Access Compliance Report

Public Rights-of-Way

(Curb Ramps)

Intersection ID: 3107	Main Street: GROSBEAK_LN	Cross Street: MOURNING_DOVE_LN	Location:	S
ADA ID: CA053BBEE8EE	Ramp Type: Perp	Initial Pass/Fail: Fail	Overall Compliance: No	Severity Score: 8.75
Codes/Mitigation Info/Possible Solution		Field Measurements/Component Compliance

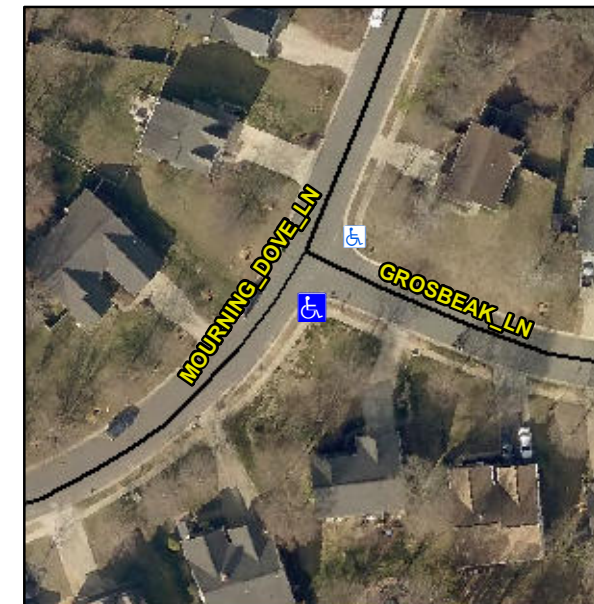
R304.5.1

Remove & Replace Entire Ramp.
